From: Scannell, Luke W (DEC) <luke.scannell@dec.ny.gov>
Sent: Friday, December 18, 2020 8:22 AM
To: Gasic, Drazen
Subject: Re: NYSDEC Solar Guidance
Attachments: 20200916_145002.jpg; 20200916_145004.jpg

In the NYSDEC Region 8, we are currently willing to accept the following design criteria in regard to solar panel installations:

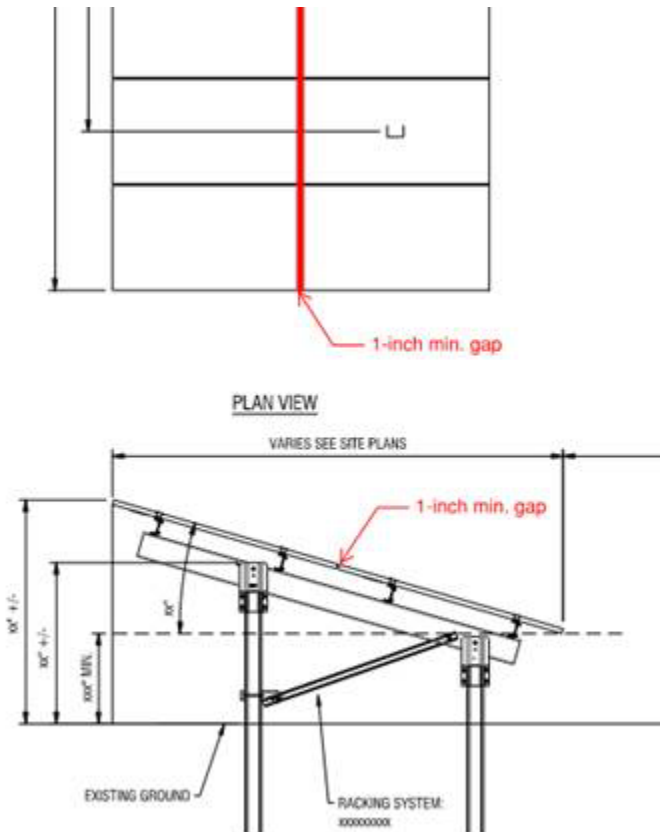
Update 1: If the developer is able to provide a min. 1-inch space between the modules horizontally, then the DEC would be willing to consider not requiring flow diffusers for slopes between 5-10%. The rationale for this is that having the gap breaks up the potential accumulated sheet flow created on the modules. The DEC is also in favor of the modules being in landscape over portrait as that again reduces the surface sheet flow on the modules.

Update 2: If we need to place modules in slopes greater than 10%, the DEC is willing to review calculations for water bars that are sized and designed based on the NYS Erosion Control Book (Blue Book) with the attached clarification. . The intention is to make the water bar parallel to the contour with as close to 0% cross slope, and allow water to transition from shallow concentrated flow, from solar panels, to sheet flow.

Yes, that is essentially correct for point 1. For point 2 we don't recommend trying to use water bars as level spreaders, use either or. More formally:

1. On 5-10% slopes it is our experience that solar panel projects with the panels arranged as shown in the attached photos, including a 1" gap between panels, will avoid creating concentrated flow paths on a well vegetated site. In such cases, flow diffusers, or other dripline features are not required as suggested in the Maryland Solar Guidance.

However, if the topography of the slope is such that it concentrates flows coming off the panels, other erosion controls may be necessary. Additionally, temporary stabilization will be needed on erosive soils until a dense vegetated cover can be established.

2. On slopes 10% or greater, additional controls are required. These can take the form of water bars or level spreaders. We are not recommending that water bars be used as level spreaders. For both practices they should be implemented across the slope at the recommended frequency as indicated in the Blue Book detail for water bars. That is every 75' for slopes between 10 and 20%.
